THE COMMISSIONERS OF THURMONT

Memo

To: Planning & Zoning Commission
From: Kelly Duty, Planner
cc: Jim Humerick, CAO
Date: March 19, 2026
Re: **The Meadows – Major Subdivision Concept Plat
304 Apples Church Road – Cross & Company, LLC**

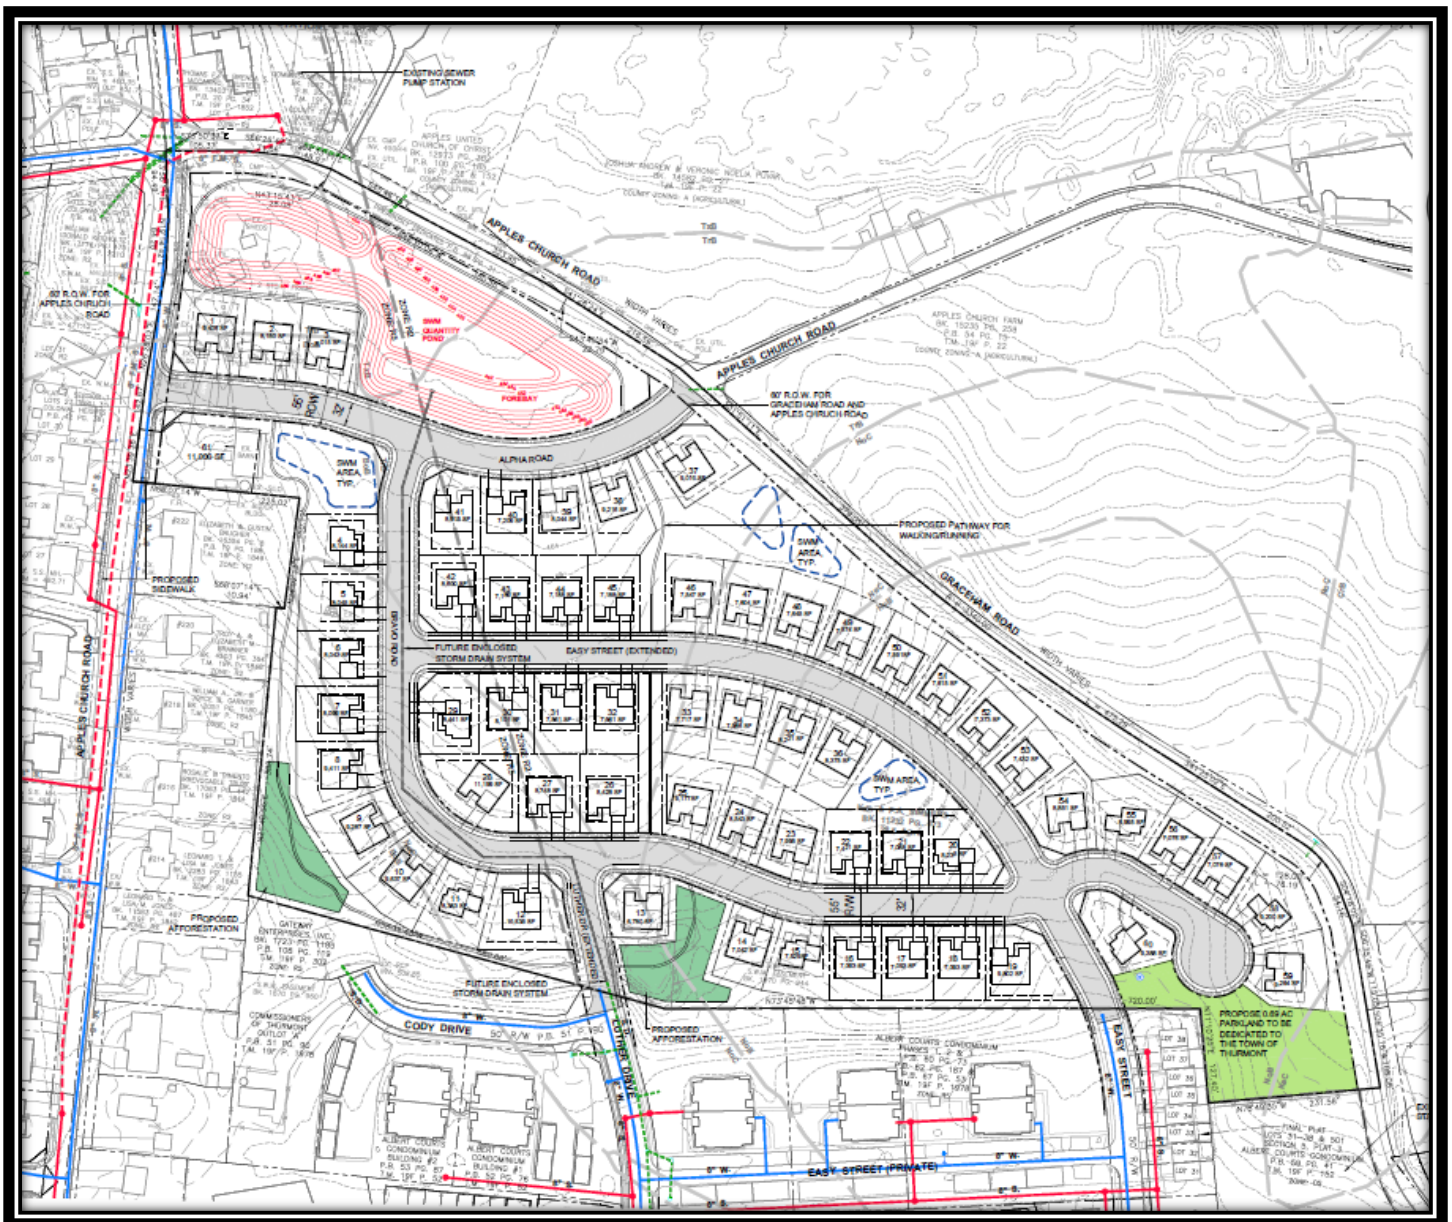
1. The plat provides zoning designations on the adjoining parcels. The parcel adjoins both R-2 and R-5 zoning in Town limits.
2. The property is zoned R-2 and R-5 Residential.

3. The proposal includes 61 single-family dwellings, associated roadways, community amenities, and stormwater management facilities.
4. The proposed density is approximately 2.5 dwelling units per acre, which is below the maximum permitted density for both the R-2 and R-5 zoning districts.

6. Lot 61: provide building restriction lines, dwelling location, and driveway access from "Alpha Road".
7. Lot Standards:
 - R-5 District: Minimum 8,000 square feet; minimum lot width of 70 ft. The Concept Plat demonstrates compliance.

12. The applicant shall clearly demonstrate how the parkland requirement is satisfied, including any afforestation credit and any requested fee-in-lieu or waiver. A separate plan sheet shall delineate all parkland and open space areas.
13. The proposal supports the Thurmont Master Plan objective of interconnected open space through expansion of the existing park and provision of trail connections.

14. The Thurmont Master Plan emphasizes interconnected streets and pedestrian accessibility. The proposed sidewalk network provides internal circulation and connections to existing sidewalks along Luther Drive/ Cody Drive intersection, Easy Street, and Apples Church Road.

15. Carroll Street Park is adjacent to the site and will be directly accessible to residents.
16. Neighborhood connections to Luther Drive and Easy Street are consistent with prior Planning and Zoning Commission direction and were supported by emergency services during the annexation process. Traffic calming measures are to be determined during the subdivision review process where the connections occur at Luther Drive and Easy Street.

24. The developer shall replace the existing sanitary sewer pump station to accommodate proposed flows. The new facility shall include a deeper wet well to allow gravity flow, pumps sized for peak flow with redundancy, modern controls with alarm capabilities, a separate valve vault, and all associated infrastructure. The developer shall replace the existing sanitary sewer pumping station with a new facility designed to accommodate gravity flow from the proposed development and existing system demands, including a deeper concrete wet well to prevent surcharge and pump short-cycling; pumps sized for maximum flow with redundancy (1+1), installed on slide rails; a control panel with automatic lead/lag alternating operation and alarm auto-dialer; a separate valve vault with check and isolation valves; an aluminum access hatch for maintenance; and a pole-mounted LED site light (switch-controlled). All manholes shall be located within roadways for access, all sewage from dwellings shall flow by gravity to the
